October 28, 2015

RICHARD G. SYKES DIRECTOR OF WATER AND NATURAL RESOURCES (510) 287-1629 (510) 287-1629

SUBJECT: Comments on the Bay Delta Conservation Plan Partially Recirculated Draft Environmental Impact Report/Supplemental Draft Environmental Impact Statement

Figure 2. Projected Shasta Reservoir Carryover Storage, NAA, NAA-ELT and NAA-LLT

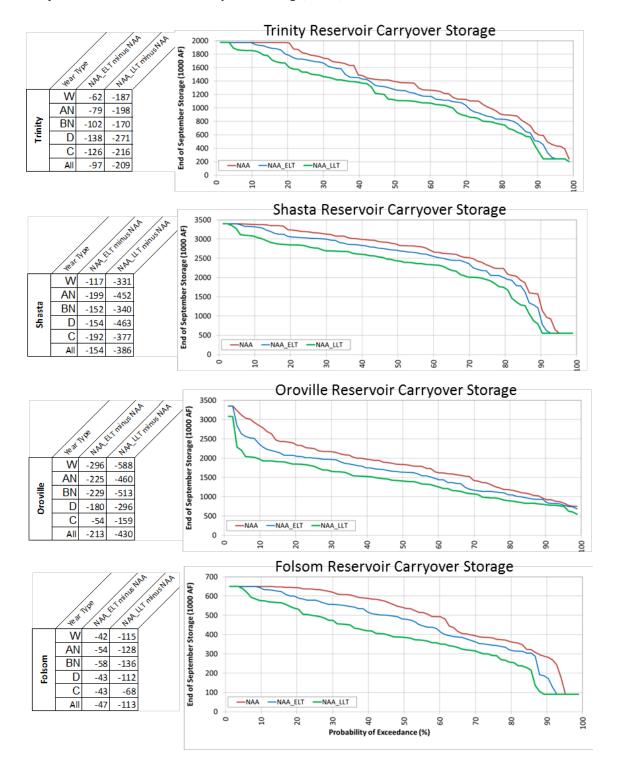
Figure 2 illustrates the typical change in carryover storage as shown for Trinity, Shasta, Oroville, and Folsom Reservoirs. The relatively high frequency (approximately 10% of time) of minimum storage occurring at CVP reservoirs illustrates our questioning of credible operations in the studies.

Figure 3. Projected Inflow to Millerton Lake -NAA, NAA-ELT and NAA-LLT

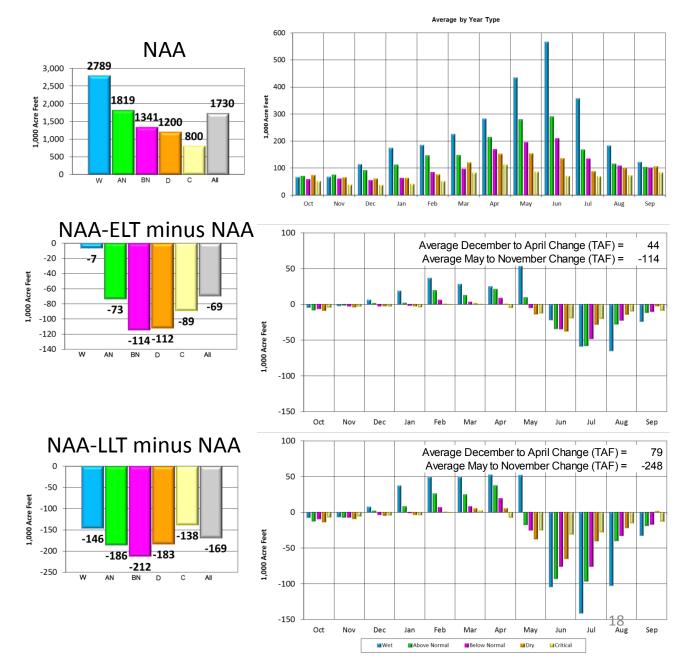
San Joaquin Valley reservoirs are depicted with an overall decrease in annual runoff with some shifting of runoff from spring to winter, but mostly just decreases in spring runoff due to a decline in snowmelt runoff during late spring⁵. Figure 3 illustrates the assumed effects of climate change upon inflow to Millerton Lake.

The hydrology differences imposed in the NAA Scenarios of the Friant Division are described above, and its appropriateness may be subject to additional debate and Alternative assumptions. However, our review found that implementation of Millerton Reservoir inflow as affected by climate change was improperly performed.

Figure 22. Alt 4-ELT North Delta Diversion Versus South Delta Diversion for July, August, and September

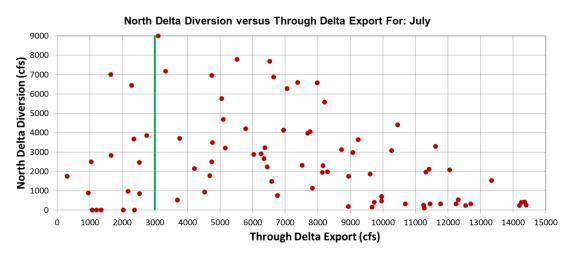
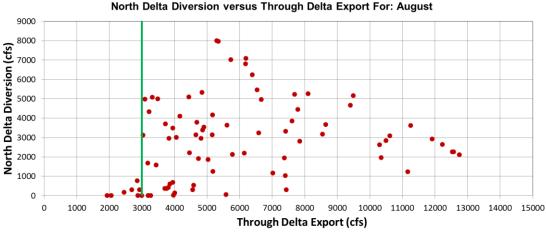
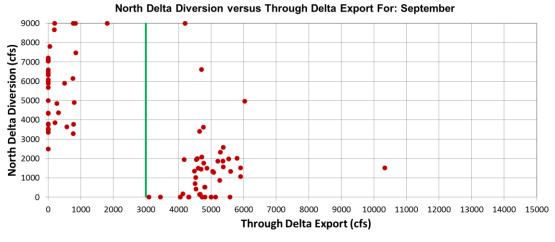
Figure 22 contains figures for July, August, and September for Alt 4-ELT that plot NDD against SDD. In the months of July to September SDD are occasionally very high, exceeding 14,000 cfs in July, with minimal NDD. This occurs due to outdated model code that imposes an instream flow requirement in Sacramento River flow below Hood in excess of the bypass criteria prescribed in the BDCP. There are numerous occurrences when bypass flows prescribed in the BDCP are exceeded and SDD are higher than expected. On the other hand, there are also many times when NDD are above minimum pumping levels and SDD are below the BDCP prescribed 3,000 cfs threshold indicated by the green line in Figure 22. For unknown reasons, the model code requiring SDD to be greater than 3,000 cfs before NDDs occur from July through September is deactivated in the BDCP modeling of this Alternative.

Figure 23. South Delta Diversion at Banks

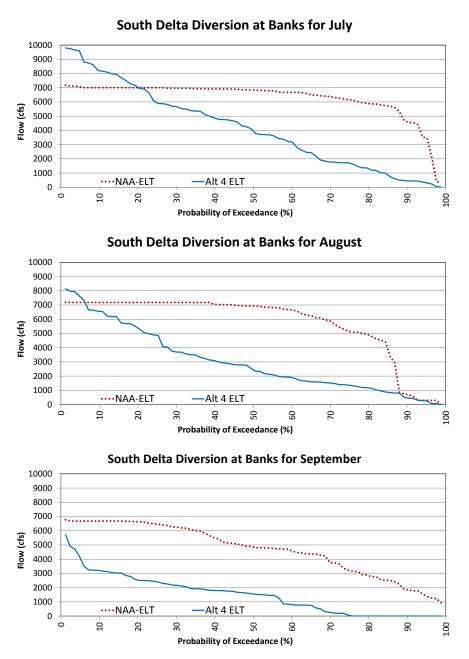
South Delta Diversion at Banks is not limited to existing permit capacity of 6,680 cfs and pumping may reach full capacity of 10,300 cfs in July, August, and September. Figure 23 contains exceedance probability charts of South Delta Diversion at Banks for July, August, and September. The chart for July shows SDD at Banks exceeding existing permit capacity 20% of years, in August this occurs in about 7% of years. There are South Delta diversions at Banks 25% of the time in September while diversions from the Sacramento River may range from 2,500 cfs to 7,500 cfs.

Figure 61. Sacramento River below Hood

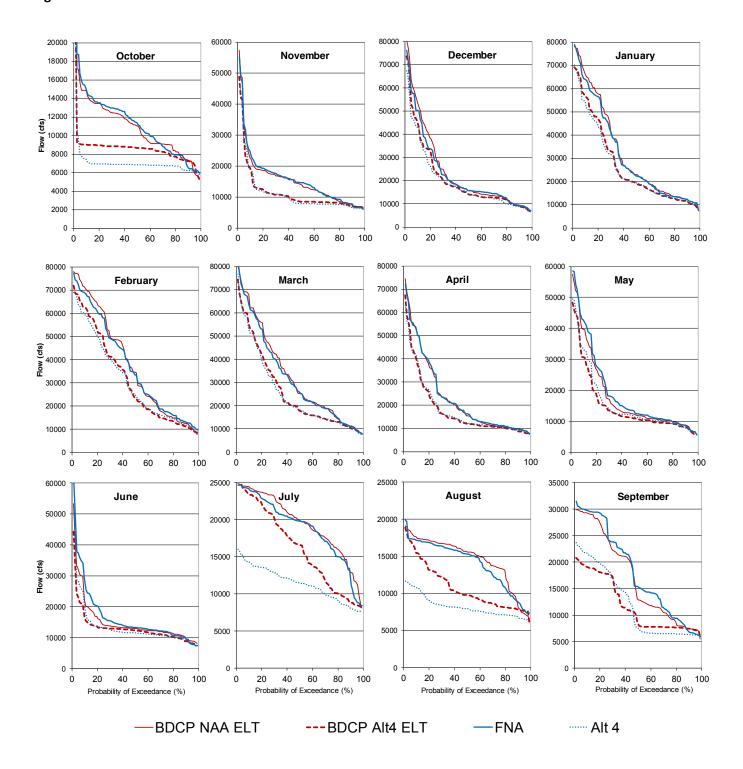
Figure 61 contains monthly exceedance probability plots for Sacramento River below the NDD for the following scenarios: 1) BDCP NAA-ELT, 2) BDCP Alt 4-ELT, 3) independent modeling FNA, and 4) independent modeling Alt 4. The most significant differences in flow changes occur in October, July, August, and September. Changes in Sacramento River flow entering the Delta are a key indicator of changes in interior Delta flows, water levels, and water quality.

In the independent modeling September flows are reduced by about 6,100 cfs while BDCP modeling shows a reduction of about 5,300 cfs. The independent modeling shows Sacramento River flow entering the Delta to be about 7,000 cfs 50% of the time, BDCP modeling show Sacramento River flow is about 8,000 cfs 50% of the time.

Figure 1 Mokelumne Aqueducts and Proposed Delta Tunnel Plan

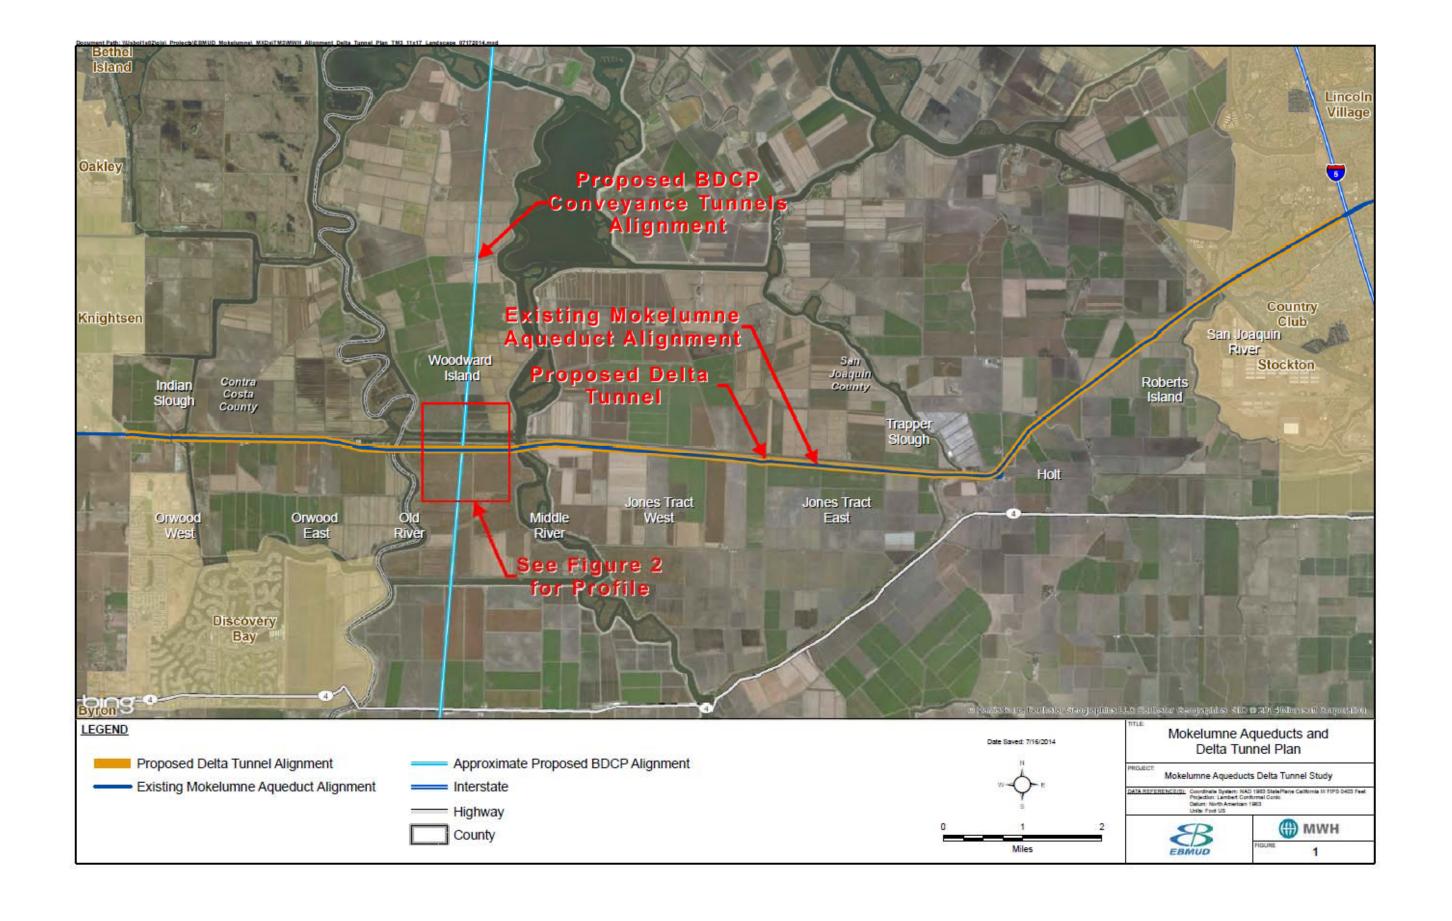
The BDCP Conveyance Tunnels are shown in the DEIR/EIS to cross the EBMUD Aqueducts in the middle of Woodward Island, which is within the Delta area, and is shown on **Figure 1** - **Mokelumne Aqueducts and Proposed Delta Tunnel Plan.** Within the crossing location, all three Aqueducts are elevated and on piles, with pile tips ranging from approximately 30 to 50 feet deep, corresponding to elevations of -40 to -60 feet msl.

Figure 3-9 of the DEIR/EIS (alignment of alternative 4 tunnels) shows shafts approximately 1.5 miles to the north and to the south of the EBMUD Mokelumne Aqueduct. However, we note that the shaft locations could change in subsequent design phases, and include shafts near the EBMUD Mokelumne Aqueducts and proposed Delta Tunnel. If shafts are located near EBMUD facilities there would be substantial impacts from construction and operation that are not included in these review comments.

The BDCP/Alternative 4A RDEIR/SDEIS must address this reasonably foreseeable conflict, and EBMUD expects the project to avoid tunneling within the -100 to -143 ft msl elevation range at the site of the tunnel intersection and also to provide an appropriate additional buffer between the two facilities.

Figure 2 Proposed Delta Tunnel Profile

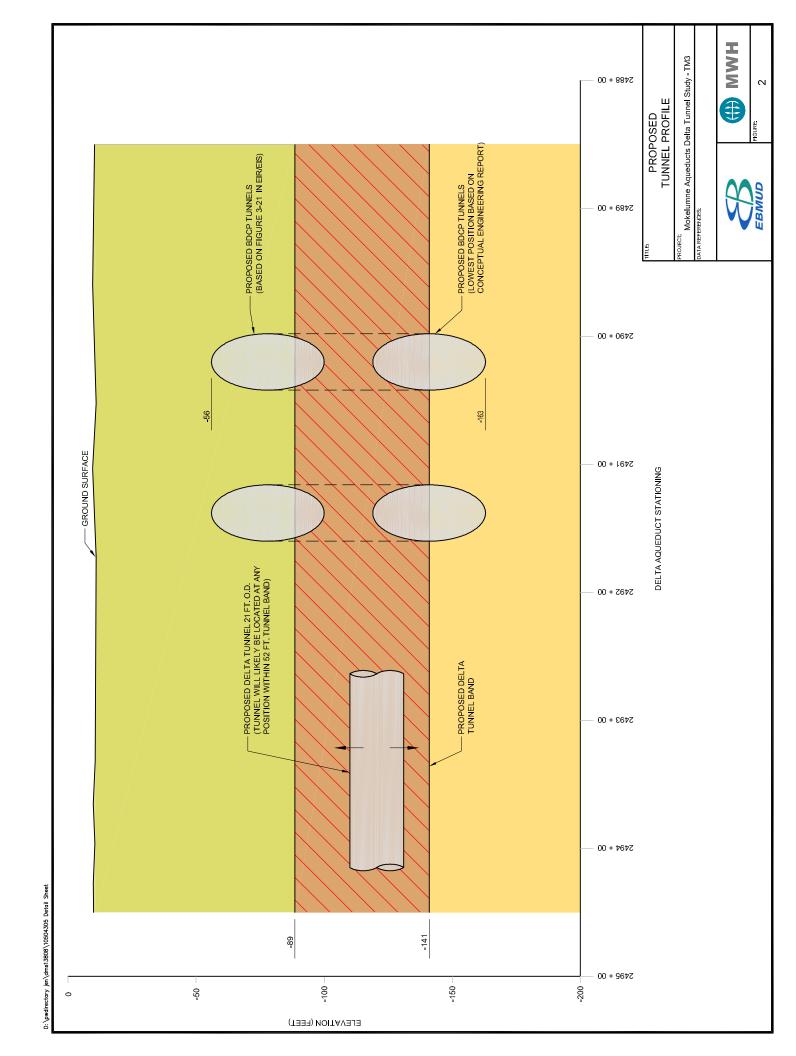
email on March 23, 2012, EBMUD staff discussed with DWR the potential conflicts between a BDCP tunnel and EBMUD's planned cross-Delta tunnel. EBMUD's design for its cross-Delta tunnel places the EBMUD tunnels within an elevation range of -100 feet mean sea level (ft msl) to -143 ft msl. Tunnel design will be developed further in the future, and subsequent design phases may identify a tunnel profile outside of these elevations. Despite prior notification given by EBMUD to DWR, the RDEIR/SDEIS documents fail to note the potential conflict, analyze the resulting environmental impacts, or propose mitigation.

The proposed tunnels would be constructed with large-diameter TBMs through launch/retrieval shafts at approximately 3-mile intervals. Figure 3-21 of the EIR/EIS shows the tunnels with a "Typical depth of 100 ft. msl".

The DWR's Conceptual Engineering Report (2010), referenced within the DEIR/EIS, states: "the tunnel invert is assumed to be at 100 feet below mean sea level (msl) primarily to avoid peat deposits" and goes on to state that it would be lowered down to 160 feet below msl at the San Joaquin River and the Stockton Deep Water Ship Channel. Figure 11-6 of this report shows the tunnels with an invert depth of approximately 150 feet below msl. Moreover, in a recent update to the CER dated October 2013, for the Modified Pipeline Tunnel Option, the preliminary tunnel inverts range from 122 feet below msl at the north end of the North Tunnel at Intake No. 2 to 163 feet below msl at the North Clifton Court Forebay.
